DOCKET 50-255 - LICENSE DPR-20 -
PALISADES PLANT - SEP TOPIC VI-7.C.1, INDEPENDENCE OF
REDUNDANT ONSITE POWER SOURCES

By letter dated November 18, 1980, the NRC issued for comment a draft evaluation of SEP Topic VI-7.C.1 for the Palisades Plant. Attached are the Consumers Power Company comments on that document.

PALISADES PLANT - SEP TOPIC VI-7.C.1
COMMENTS ON NRC EVALUATION

SCHEMATIC DIAGRAM
PRESSURIZER PRESSURE CONTROL & MEASUREMENT CHANNEL INSTRUMENTATION

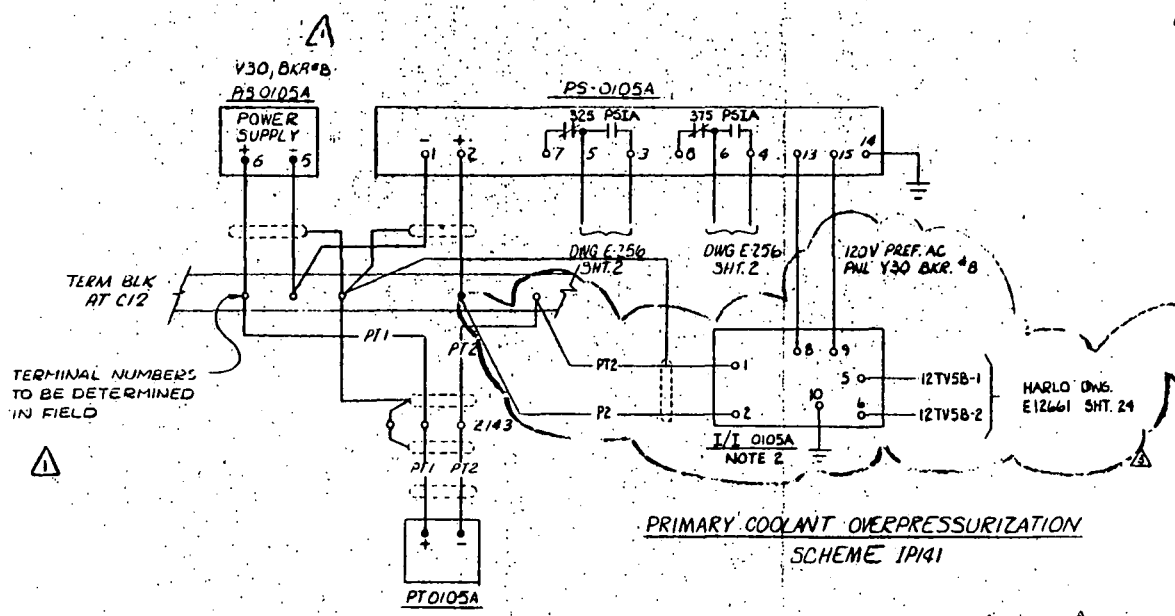
| Indication Requirement | Necessary Transmitter/Indicator and (or) Recorder | Power Supply | Applicable Drawing (Attached) | Comments |
|---|---|---|---|---|
| 2) one wide range pressurizer pressure channel | 2a) PT0103/PI0103<br><br>2b) PT0105A or B/ sub-cooled margin monitor | 2a) panel YO-1<br><br>2b) preferred panels Y-30 for PT0105A & Y-40 for PT0105B | 2a) E-84-3, M-311-01-5<br><br>2b) E-84-6, M-311-01-6, M-311-01-6A | 2) The preferred wide range indicator PI0103 is supplied by the non-redundant YO-1 supply. The sub-cooled margin monitor is fed from the preferred supplies. Although the sub-cooled monitor does not provide a direct pressurizer pressure readout, its sub-cooled pressure reading can be readily converted to a direct pressurizer pressure. The ranges for these instruments are:<br>PT0103- 0-3000 psi<br>PT0105A&B - 0-2500 psi |

SCHEMATIC DIAGRAM
PRESSURIZER LEVEL CONTROL
INSTRUMENTATION

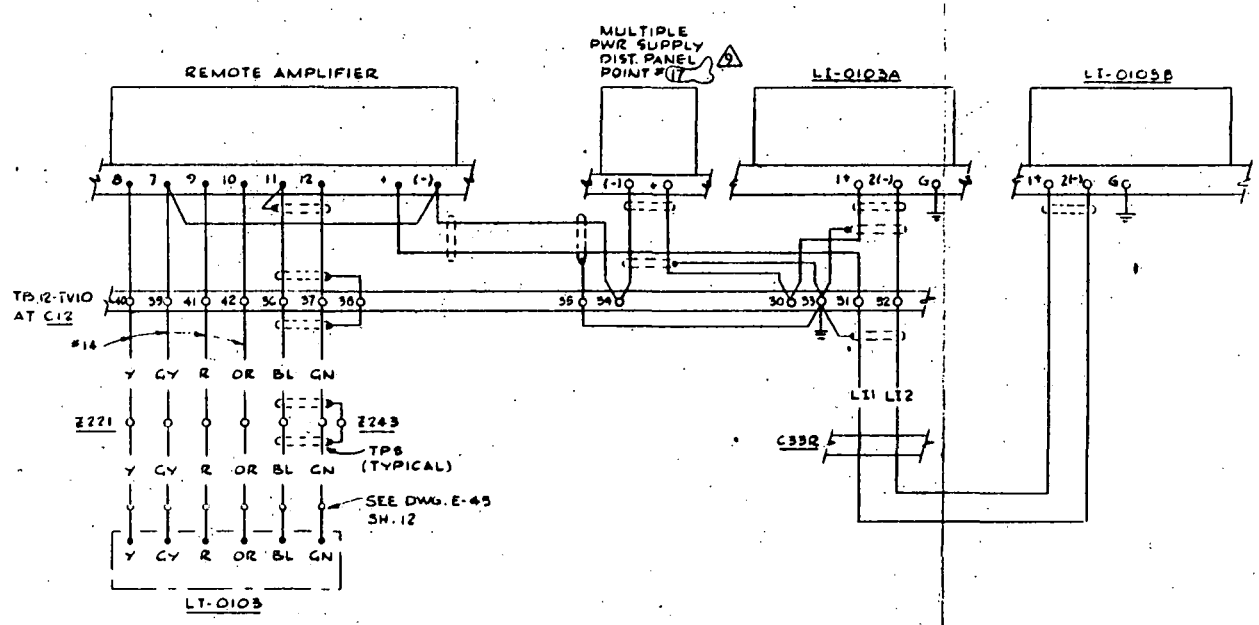
| Indication Requirement | Necessary Transmitter/Indicator and (or) Recorder | Power Supply | Applicable Drawing (Attached) | Comments |
|---|---|---|---|---|
| 4) one wide range channel of pressurizer level | 4) LT0101/LIC0101 A or B<br>LT0102/LIC0102 A, B, C, D | 4a) Y-10<br>4b) Y-20<br>a) Y-10<br>b) Y-20<br>c) Y-30<br>d) Y-40 | 4) E-82-1, 2<br>E-82-4 | 4) Multiple indication is available through the LT0101 and 0102 schemes. The range of these instruments is 100.7" to 236". The range differs from the LT0103 scheme by applied density corrections. All are fed by the preferred AC supplies. |

SCHEMATIC DIAGRAM
STEAM GENERATOR LEVEL
INSTRUMENTATION

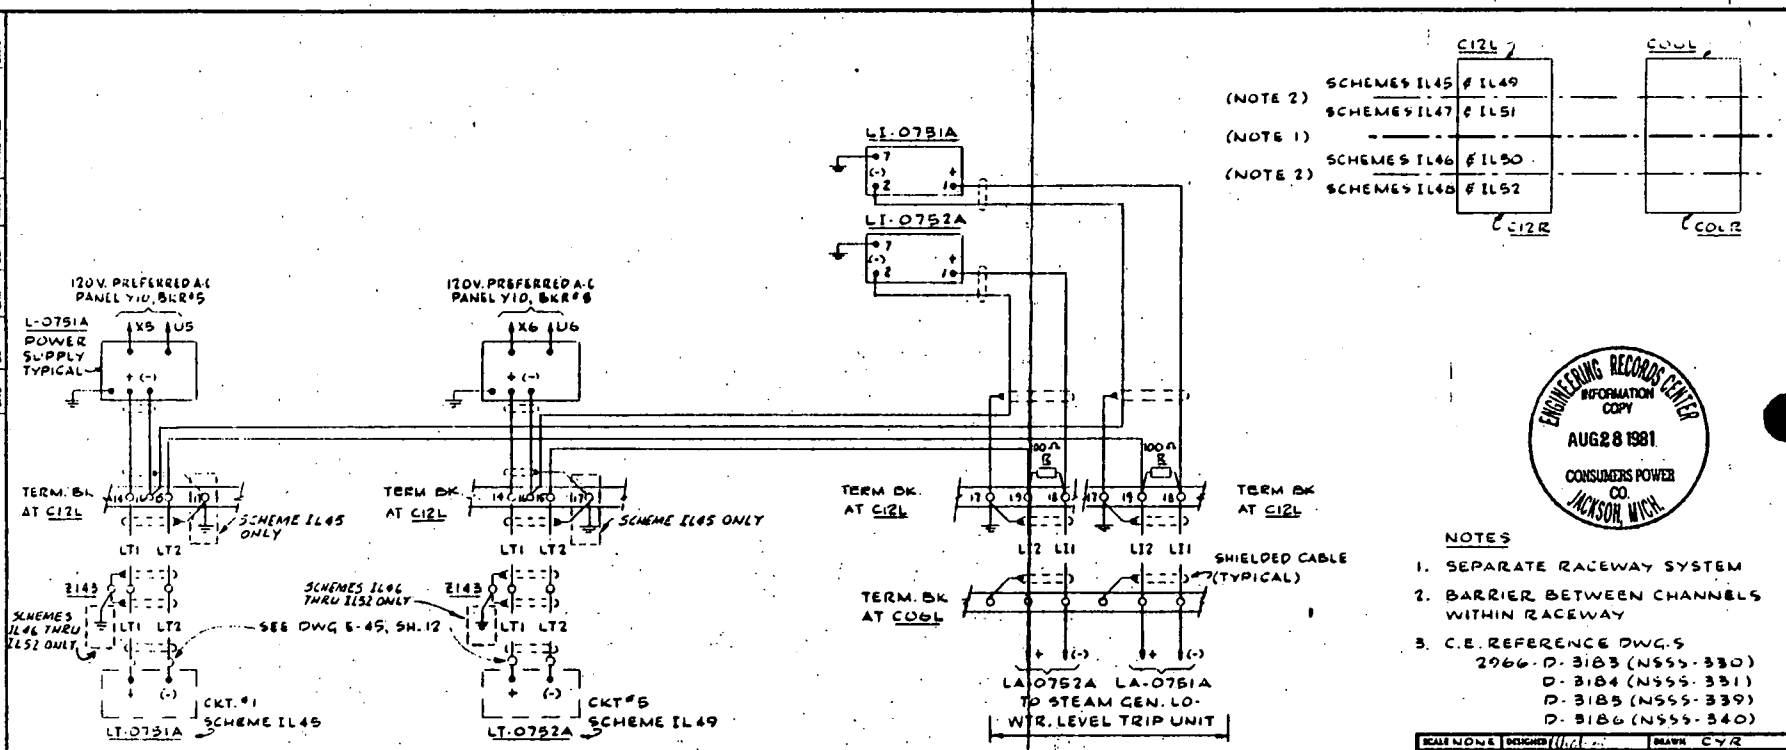
| Indication Requirement | Necessary Transmitter/Indicator and (or) Recorder | Power Supply | Applicable Drawing (Attached) | Comments |
|---|---|---|---|---|
| 1) one level channel per steam generator | 1a) steam generator E-50A: LT-0751 A, B, C or D/LI-0751 A, B, C or D<br><br>1b) steam generator E-50B: LT0752A, B, C or D/LI-0752 A, B, C or D | 1) preferred panels Y-10, Y-20, Y-30 & Y-40 for channels A, B, C & D, respectively | 1) E-78, M-311-07-16, M-311-07-18 | 1) All four channels of steam generator level are supplied by the preferred panels. The range of these transmitters is 39.1-174.3" W.C. It should be noted that letter: R A Vincent to D M Crutchfield (NRC), dated 8/17/81, states in Item #26 that two wide range level channels are being installed per steam generator |

SCHEMATIC DIAGRAM
PRIMARY LOOP
INSTRUMENTATION

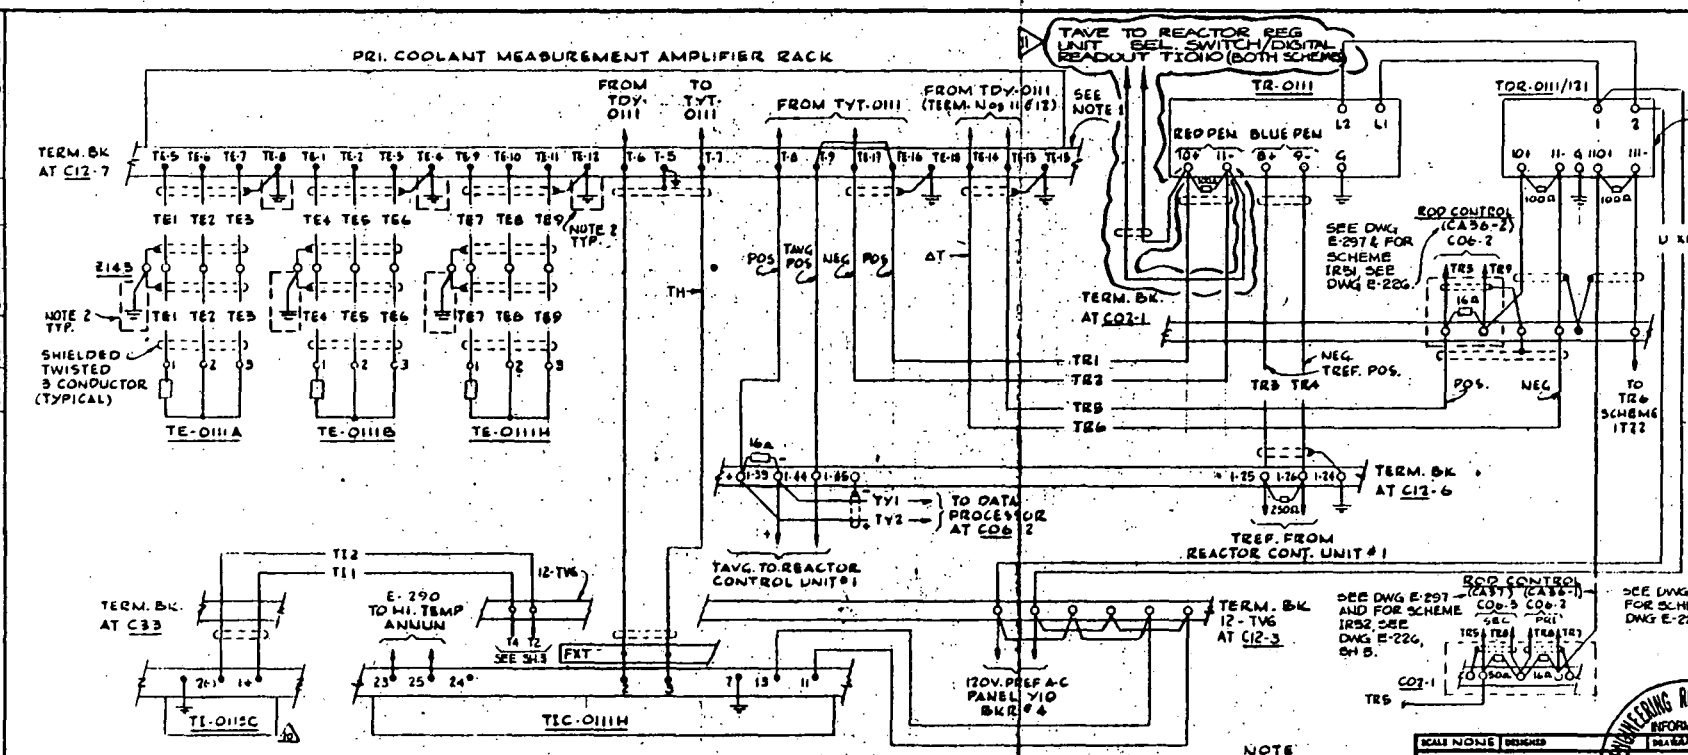
| Indication Requirement | Necessary Transmitter/Indicator and (or) Recorder | Power Supply | Applicable Drawing (Attached) | Comments |
|---|---|---|---|---|
| 3) one wide range temperature channel per PCS cold leg | 3a) cold leg 1A: TE0111A/TR0111<br>3b) cold leg 1B: TE0111B/TR0111<br>3c) cold leg 2A: TE0121A/TR0121<br>3d) cold leg 2B: TE0121B/TR0121 | 3a) Y-10<br>3b) Y-10<br>3c) Y-20<br>3d) Y-20 | 3) E-96-2<br>M-311-01-7,<br>M-311-01-13 | 3) All cold leg indicators are fed by the preferred supplies. The range of these instruments is 0-600°F. |
